HOUSTON CONSTRUCTION CODE MODERNIZATION

**SIGNIFICANT CODE CHANGES &
HIGHLIGHTS OF THE 2015 TO 2018 AND
2018 TO 2021 INTERNATIONAL
RESIDENTIAL CODE (IRC)**

Significant changes to base code requirements from 2015 to 2018 and 2018 to 2021

Changes and updates to City of Houston amendments

Irregular Buildings

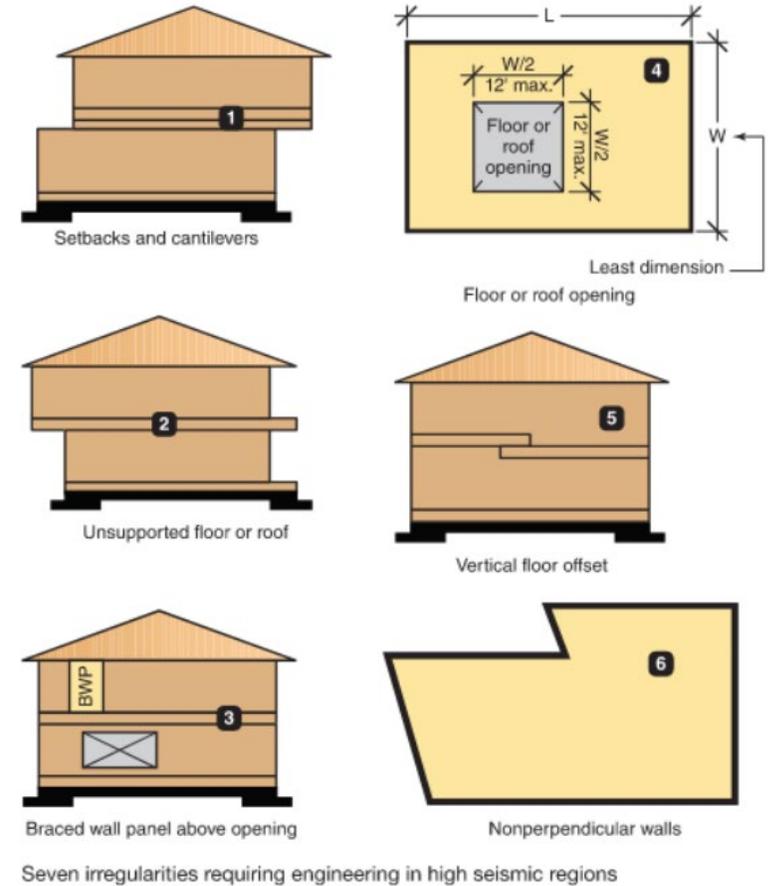
Modification. The section now clarifies that the seismic provisions are to be used for both irregular structures or portions thereof.

R301.2.2.6 modified to now include Hillside Light-Frame Construction as one of the conditions that define an irregular building.

Townhouse Separation

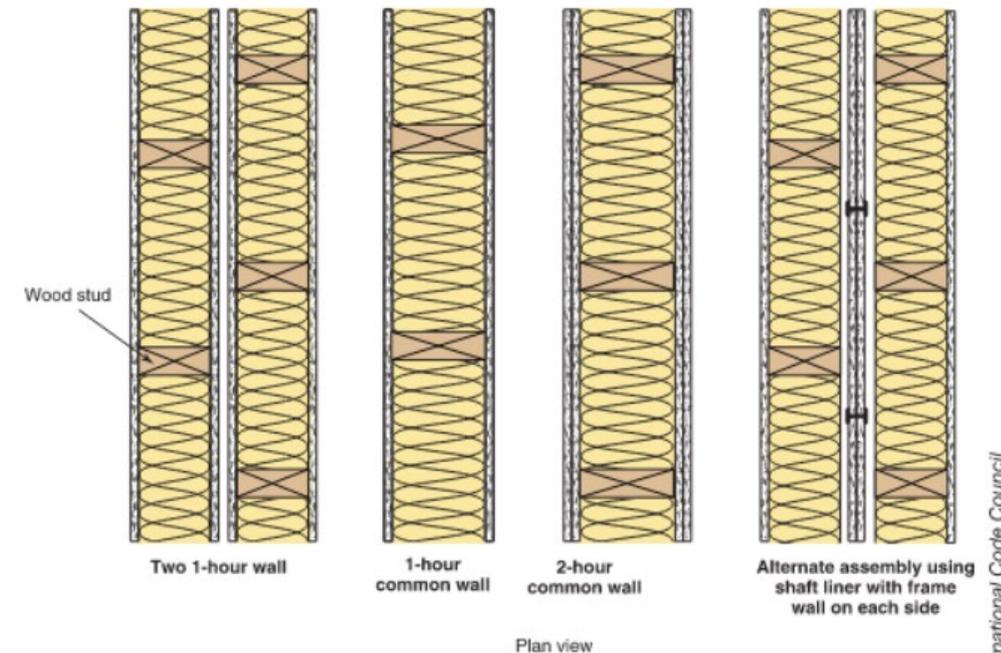
- Modification to the section to include double walls fire-resistance requirements in addition to common walls, providing two paths for compliance
- Reference to the IBC Section 703.3 added throughout section R302.2

- R302.2.1 and R302.2.2 have replaced the term Townhouse with the new more specific term Townhouse Unit.
- A new exception has been added to R302.2.2 Calling for common walls to extend to and be tight against the inside of the exterior walls
- R302.2.6 A new exception has been added to structural independence requirement of Townhouse Units based on protection by a fire sprinkler system complying with Section P2904 or NFPA 13D.

Dwelling-Garage Opening Protection

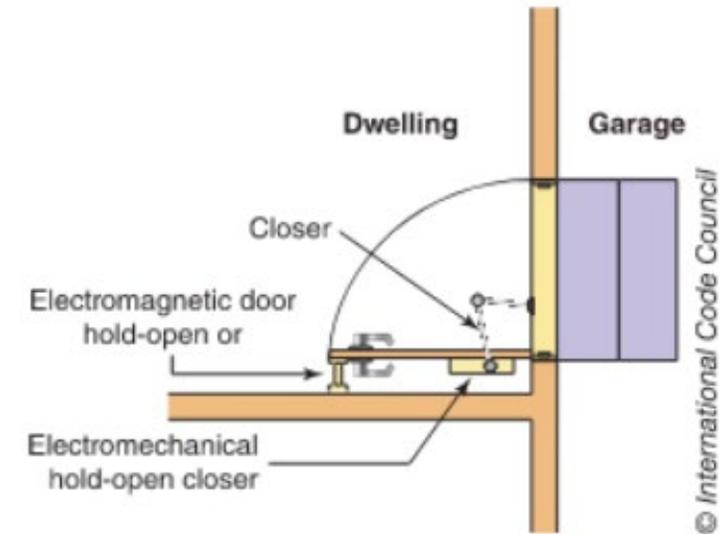
- Modification to the code permitting the use of automatic closing as an alternative to self-closing for the door between the garage and the dwelling unit.

Fire Protection of Floors above Crawl Spaces

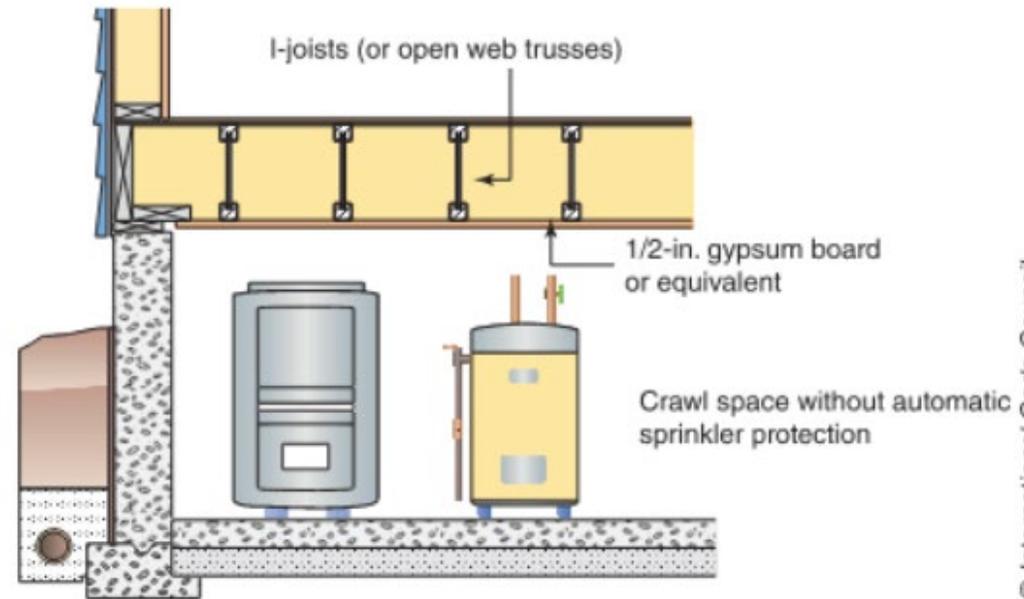
- **Exception 2 modified:** Fire-resistant membrane protection is now required for the applicable floor framing materials above crawl spaces containing fuel-fired or electric-powered heating appliances.

Prohibited Hazardous Glazing Locations at Bottom Stair Landings

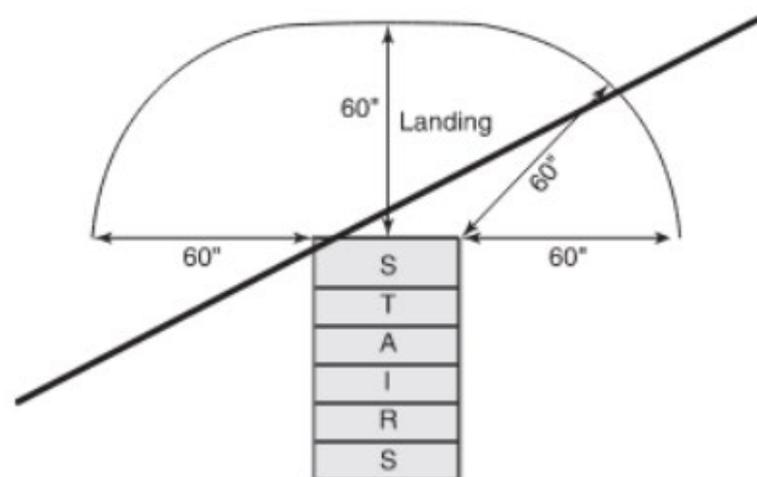
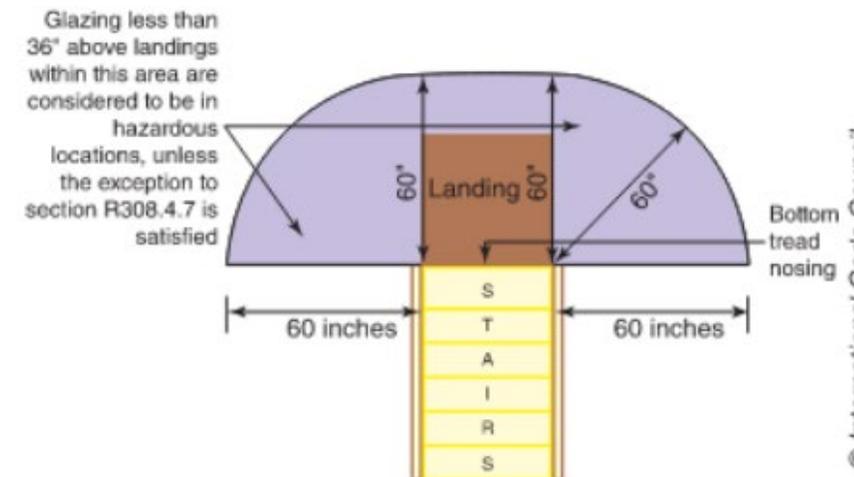
Figure R308.4.7 has been replaced with a new figure and the caption was modified to more accurately reflect the related code provision.

- The verbiage in the exception was altered for clarity

Emergency Escape and Rescue Openings

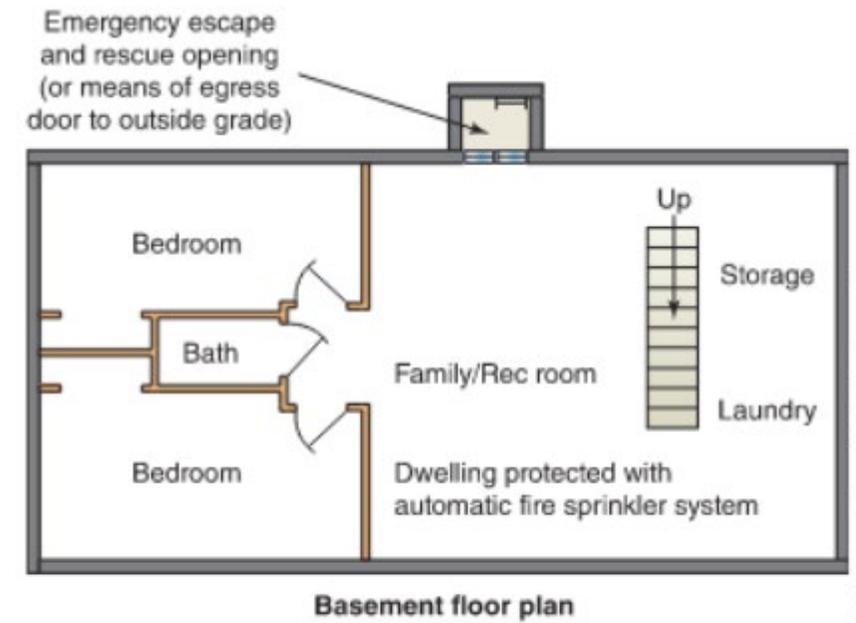
A new exception added for emergency escape and rescue.

Emergency Escape and Rescue Opening Required

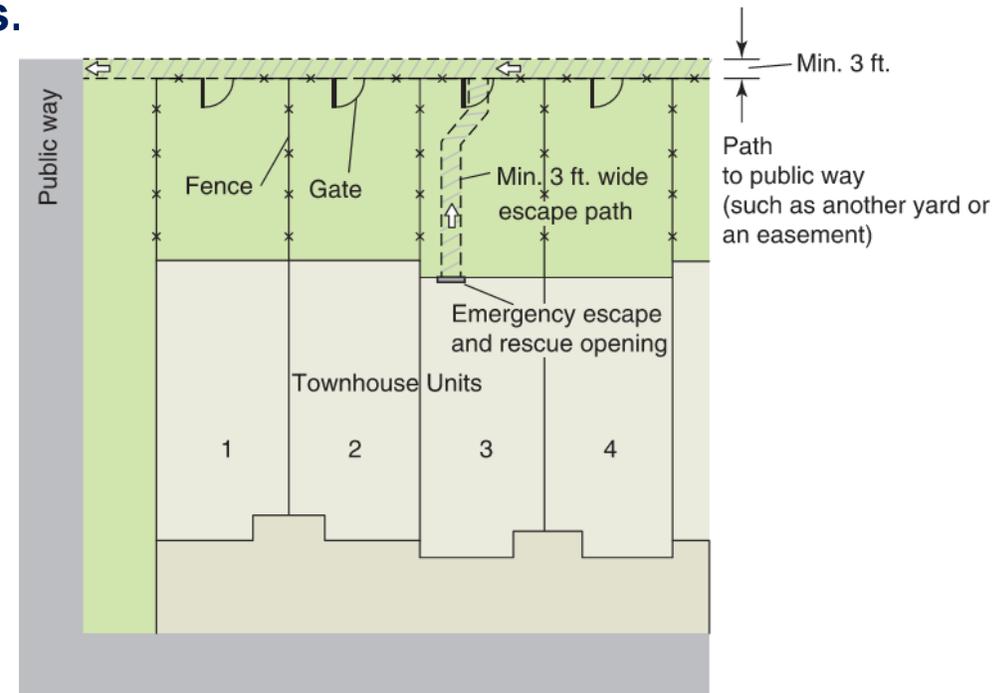
Modification to R310.1

City of Houston modifies R310.1 to include the provision that projections shall not reduce the clear width to less than 32 inches up to 80 inches above the floor or ground.

A new exception has been added to R310.1

Stairways and Ramps

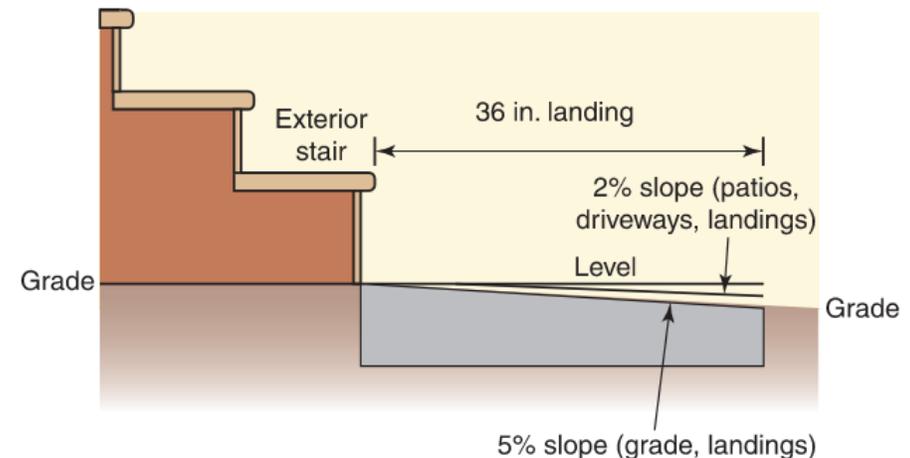
Exception added to R311.7.7 which allows for steeper slopes.

- **Exception:** Where the surface of a landing is required to drain surface water, the walking surface of the landing shall be sloped not steeper than 1 unit vertical in 20 units horizontal (5-percent slope) in the direction of travel.

Handrail Projection

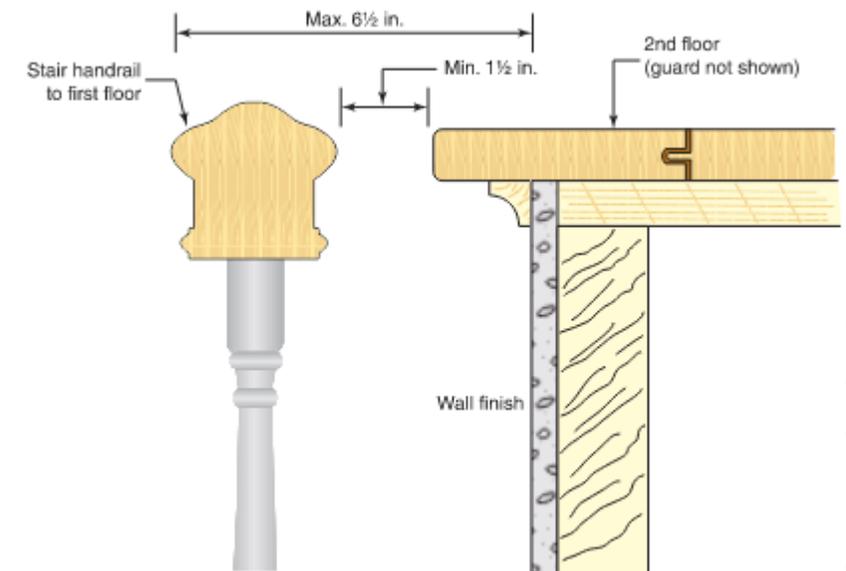
- Additional exception to section R311.7.8.2 allowing handrails to project a maximum 6.5” at nosing
- New Section R311.7.8.3 handrails adjacent to a wall shall have a space of not less than 1.5” between the wall and handrail
- Revised Section R311.7.8.4 revised for clarity and consistency

Roof Access for Photovoltaic Solar Energy System

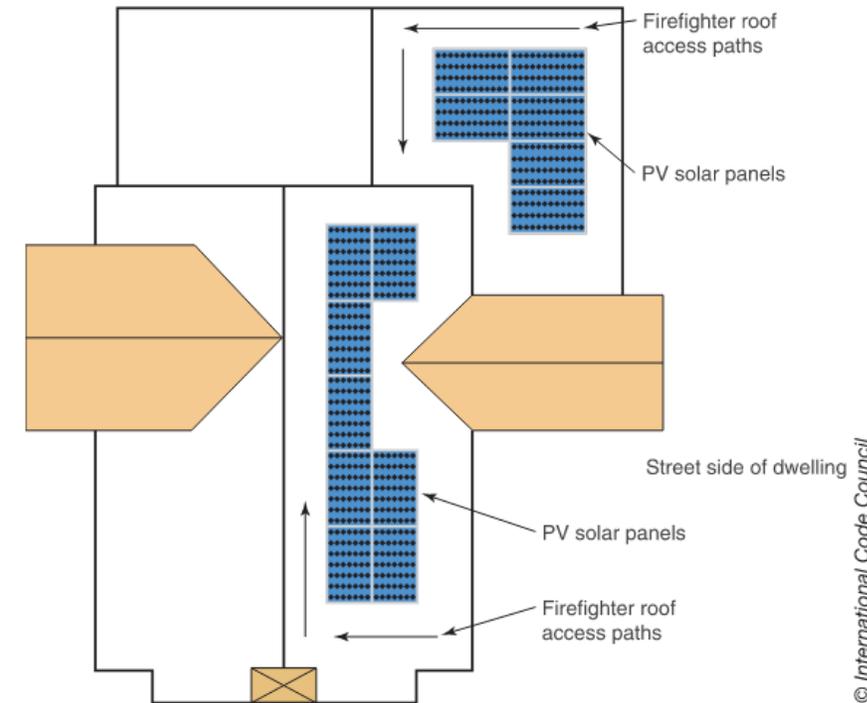
- New Section R324.6. Roof access, pathways, and setback requirements shall be provided in accordance with Sections R324.6.1 through R324.6.2.1. Access and minimum spacing shall be required to provide emergency access to the roof, to provide pathways to specific areas of the roof, provide for smoke ventilation opportunity areas, and to provide emergency egress from the roof. Exceptions:
- Detached, nonhabitable structures.
- Where code official determined rooftop operations will not be employed
- Roofs with slopes of 2 units vertical in 12 units horizontal or less

- New Section R324.6.1 Pathways. Not fewer than two pathways, on separate roof planes from lowest roof edge to ridge and not less than 36 inches wide, shall be provided on all buildings.
- Not fewer than one pathway shall be provided on the street or driveway side of the roof. For each roof plane with a photovoltaic array, a pathway not less than 36 inches wide shall be provided from the lowest roof edge to ridge on the same roof plane as the photovoltaic array, on an adjacent roof plane, or straddling the same and adjacent roof planes.
- Pathways shall be over areas capable of supporting fire fighters accessing the roof. Pathways shall be located in areas with minimal obstructions such as vent pipes, conduit, or mechanical equipment

- New Section R324.6.2 Setback at Ridge. Where photovoltaic arrays occupying not more than 33 percent of the plan view total roof area, a minimum 18” clear setback is required on both side of a horizontal ridge.
- New Section R324.6.2.1 Alternative setback at ridge. Where an automatic sprinkler system is installed within the dwelling in accordance with NFPA 13D or Section P2904, setbacks at ridges shall comply with one of the following:
 - For photovoltaic arrays occupying not more than 66 percent of the plan view total roof area, not less than an 18-inch clear setback is required on both sides of a horizontal ridge.
 - For photovoltaic arrays occupying more than 66 percent of the plan view total roof area, not less than a 36-inch clear setback is required on both sides of a horizontal ridge.

Photovoltaic Systems

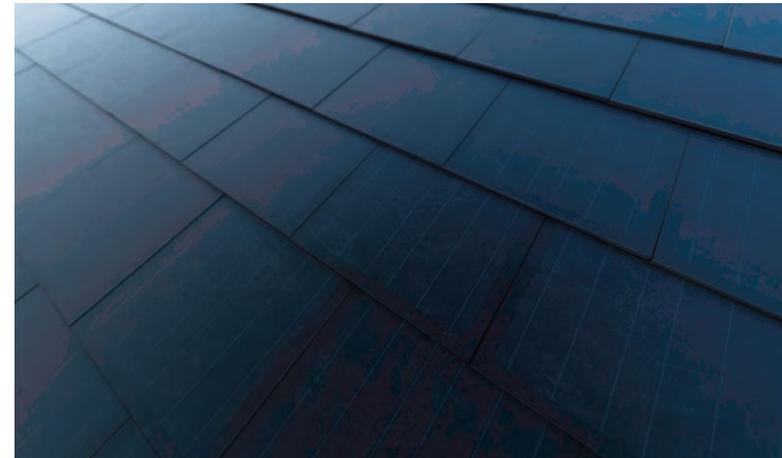
New exception to R324.6 allows Building-integrated Photovoltaic (BIPV) systems to be exempt from the R324.6 requirement to provide emergency access to the roof.

Table
R403.4

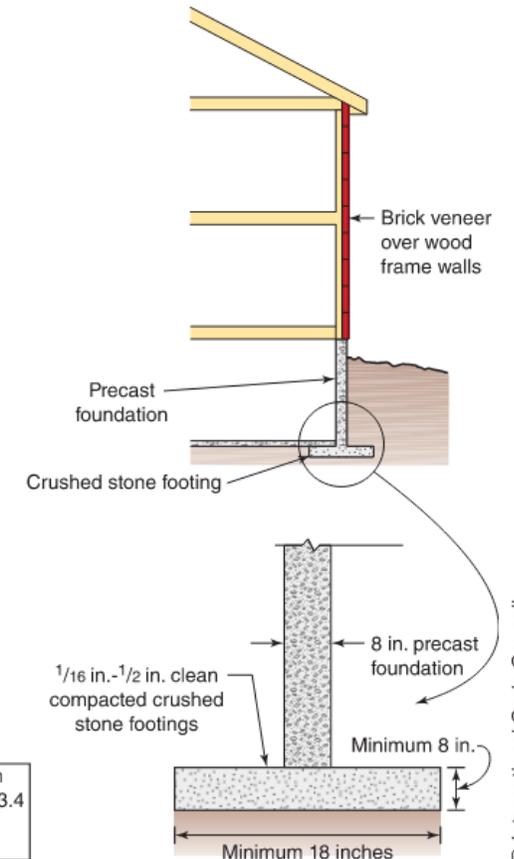
- Modification to Table R403.4. The table now includes minimum width requirements in addition to minimum depth requirements (some depth values were changed as well).
- Two footnotes have been added to the table that read as follows:
 - Crushed stone must be consolidated in 8-inch lifts with a plate vibrator.
 - Soil classes are in accordance with the Unified Soil Classification System. Refer to Table R404.5.1.

Vapor Retarders Under Concrete Slabs

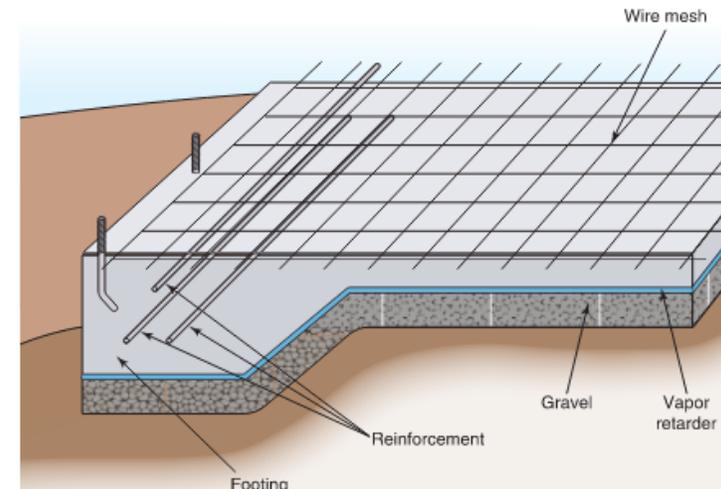
Modification to R506.2.3 requiring thicker vapor retarders below slabs-on-grade.

Alternate Stud Height

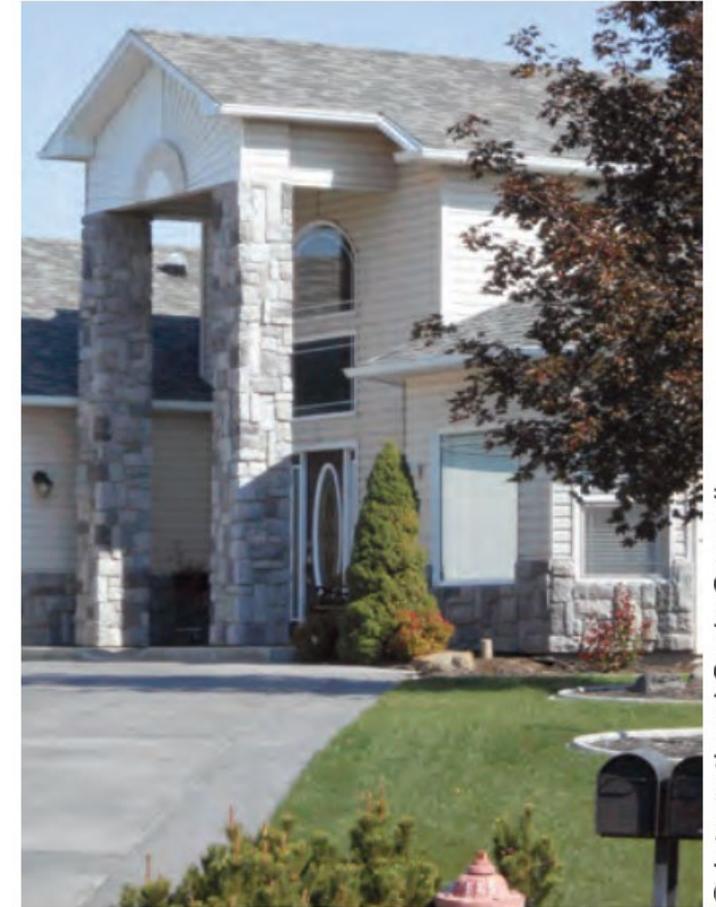
- Exception 3 added to section. Exterior load-bearing studs not exceeding 12 feet in height are provided in accordance with Table R602.3(6). The minimum number of full-height studs adjacent to openings shall be in accordance with Section R602.7.5. The building shall be located in Exposure B, the roof live load shall not exceed 20 psf (0.96 kPa) and the ground snow load shall not exceed 30 psf (1.4 kPa). Studs and plates shall be No. 2 grade lumber or better.

Method CS-PF Continuously Sheathed Portal Frame

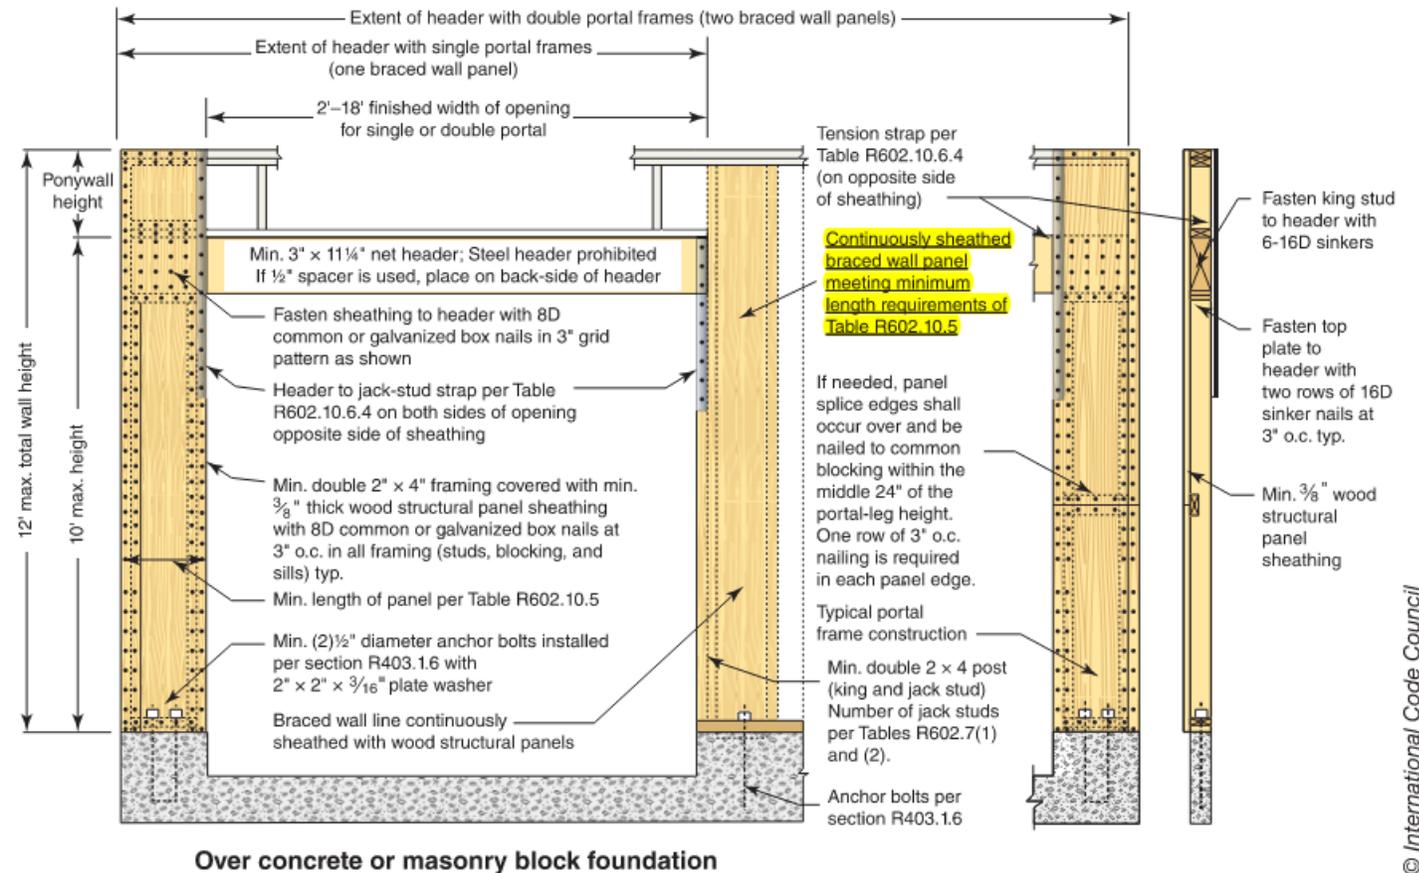
- Added text to Figure R602.10.6.4. : Continuously sheathed braced wall panel meeting minimum length requirements of Table R602.10.5

Soffit Installation

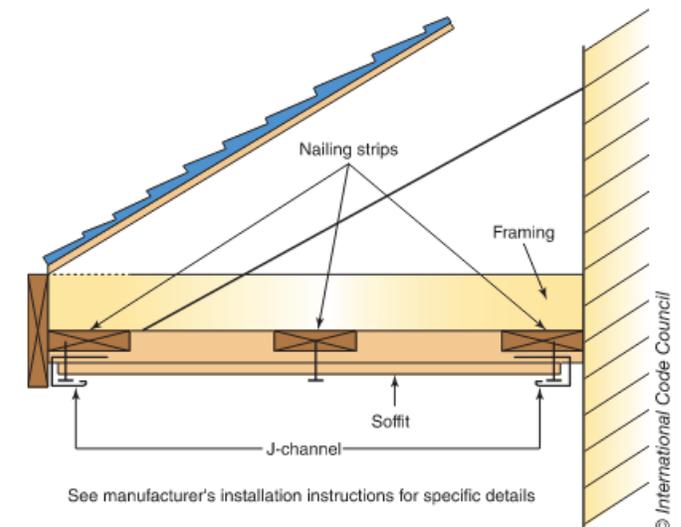
- Added Section R703.3.1 soffits to comply with Sections R703.1.1 and R703.3.1.2 or manufacturer's installation instructions.
- Added Section R703.1.1 Wood structural panel soffit. The minimum thickness shall be 3/8 inch and fastened to framing or nailing strips with 2-inch by 0.099-inch nails. Fasteners shall be spaced at a maximum of 6 inches on center at panel edges and 12 inches on center at intermediate supports.
- Section R703.11.1.4 moved to Section R703.3.1.2. Soffit panels to be supported at the fascia and wall ends and to intermediate nailing strips as necessary to ensure no unsupported span is greater than 16 inches or as specified by the manufacturer.
- Section R703.3.2 Wind limitations include soffits in the section
